Access Compliance Report

Public Rights-of-Way

Intersection ID: 11671	Main Street: PARKWOOD_AV	Cross Street: N_CALDWELL_ST	Location: S
ADA ID: 5E5F9AB22193	Ramp Type: IslandPerp	Initial Pass/Fail: Fail	Overall Compliance: No
Severity Score: 22.5			
Codes/Mitigation Info/Possible Solution		Field Measurements/Component Compliance

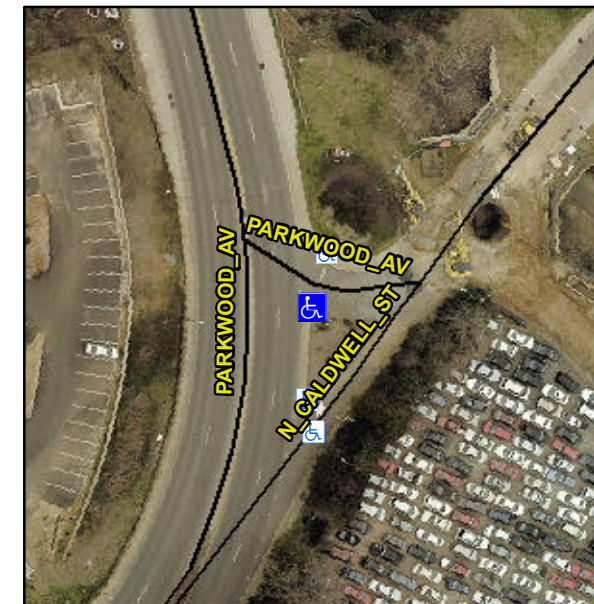
Not Found, R304.5.1, R304.2.2, R304.5.3

Compliance	Description	Data	Compliance	Description	Data
N/A	Ramp Length (in)	42.0	No	Ramp Slope (%)	8.4
No	Ramp Width (in)	40.0	No	Ramp XSlope (%)	3.6
N/A	Flare Type LT	N/A	N/A	Flare Type RT	N/A
N/A	Flare Slope LT (%)	N/A	N/A	Flare Slope RT (%)	N/A
N/A	Flare Traversable LT?	N/A	N/A	Flare Traversable RT?	N/A
N/A	Landing Length (in)	N/A	N/A	DWS Provided?	N/A
N/A	Landing Width (in)	N/A	N/A	DWS Contrast?	N/A
N/A	Landing Slope (%)	N/A	N/A	DWS Length (in)	N/A
N/A	Landing X Slope (%)	N/A	N/A	DWS Full Width?	N/A
N/A	Landing Curb? (Y/N)	N/A	N/A	DWS Offset (in)	N/A
N/A	Shared Landing?	N/A			
N/A	Gutter Ponding?	N/A	N/A	Gutter Slope (%)	N/A
N/A	Gutter Lip Ht (in)	N/A	N/A	Gutter X Slope (%)	N/A
N/A	Painted X Walk1?	No	N/A	Painted X Walk2?	N/A
	X Walk 1 Direction	To N		X Walk 2 Direction	N/A
N/A	X Walk 1 Width (in)	N/A	N/A	X Walk 2 Width (in)	N/A
	X Walk 1 Slope (%)	4.5		X Walk 2 Slope (%)	N/A
	X Walk 1 X Slope (%)	0.7		X Walk 2 X Slope (%)	N/A

Remove & Replace Entire Ramp.
